**Re: Fourth Submission Review – The Aurora Highlands North – Area A - Site Plan**  
Application Number: **DA-2062-31**  
Case Numbers: **2022-4027-00**

## Fourth Submittal Review

AURORA HIGHLANDS  
PRELIMINARY ROUNDABOUT DESIGN

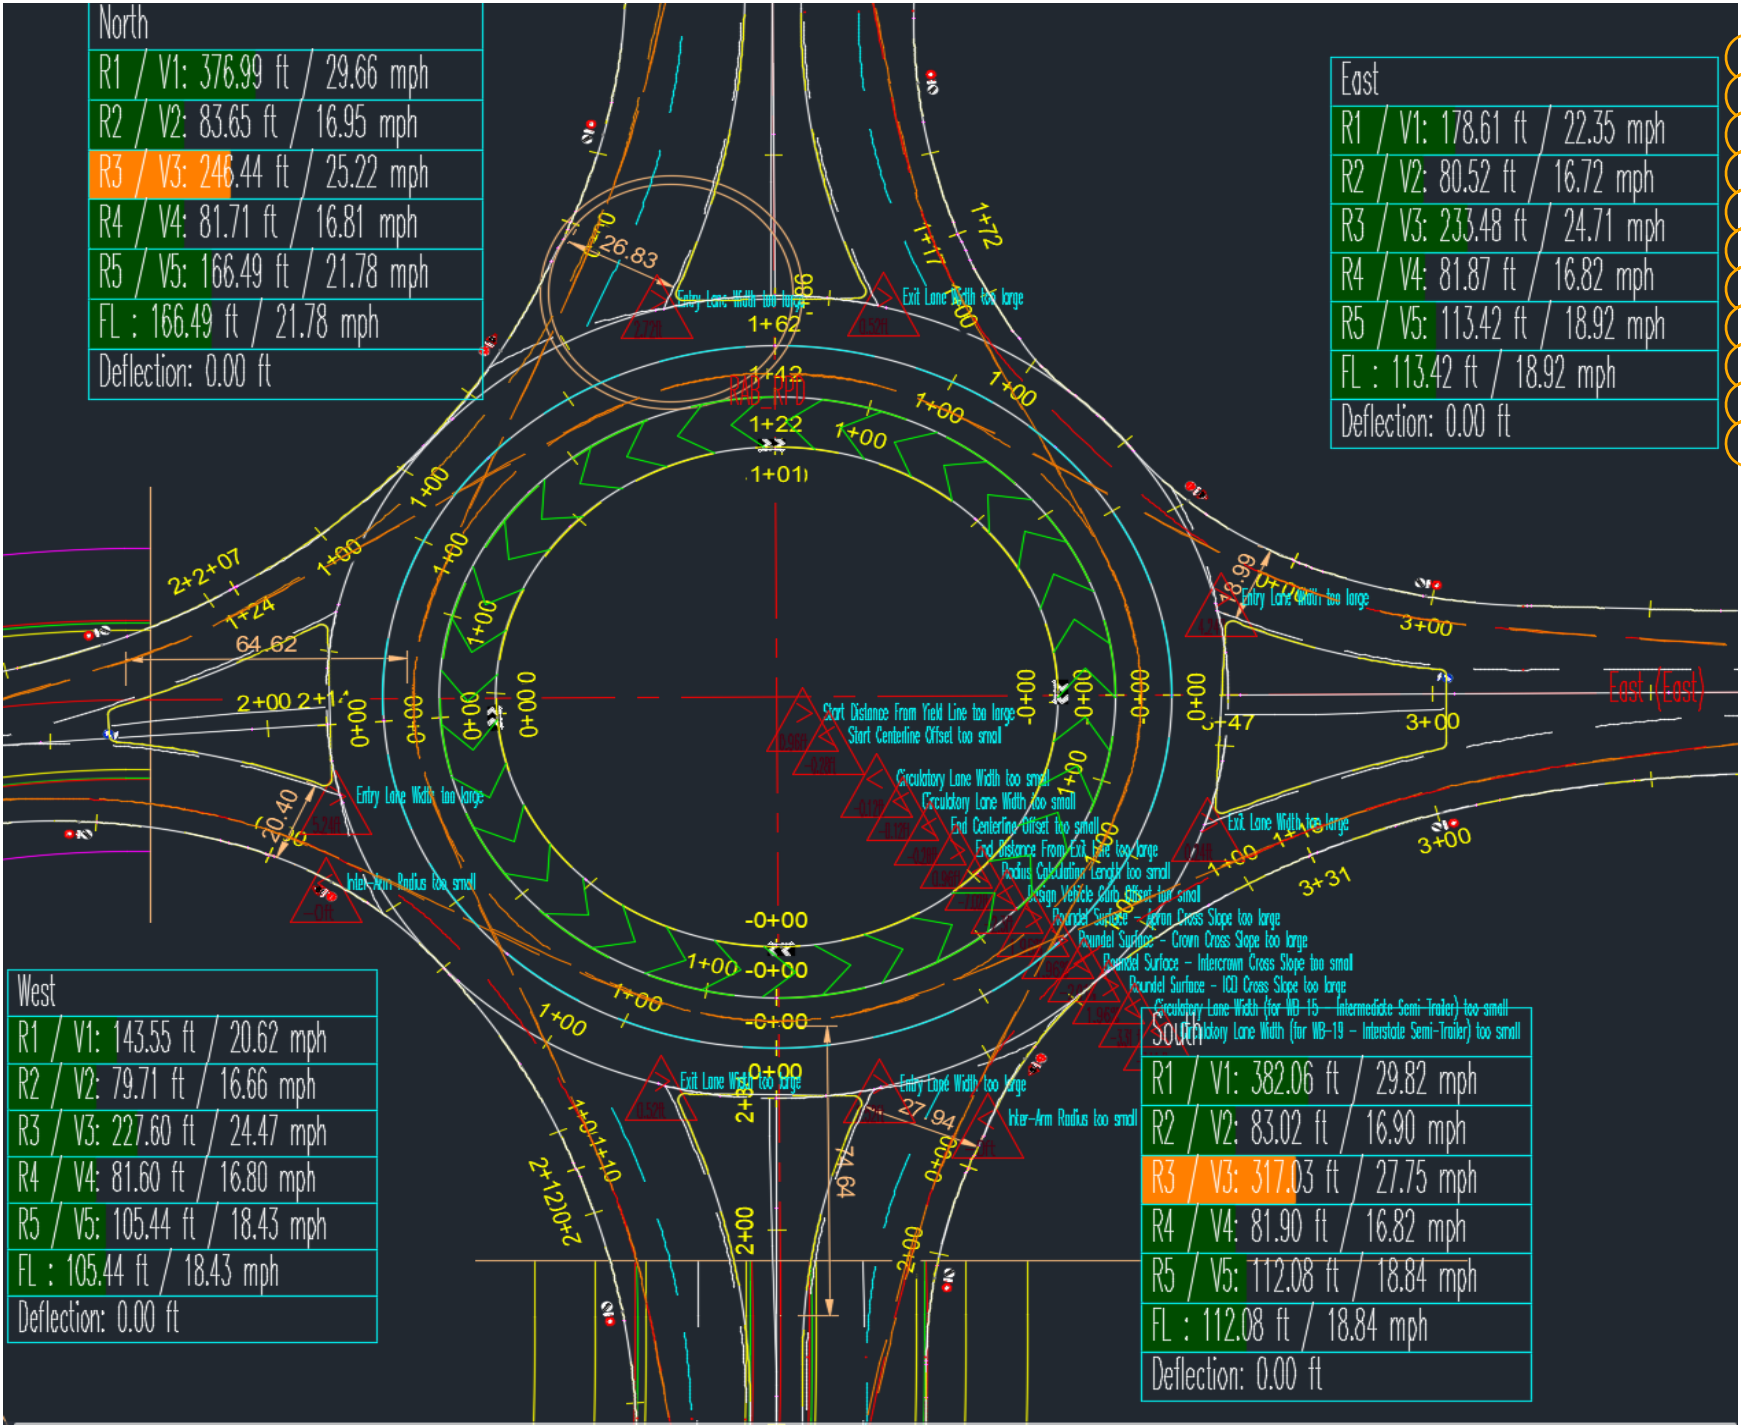
R1 speeds for north/south entry are too fast. Revising geometry to provide left offset will lower R1 values.  
R5 values are too fast. Revising outside edge geometry and providing left offset will lower R5 values.

R1 and R5 values are outside acceptable ranges, due to the large ICD and radial alignment of approaches.
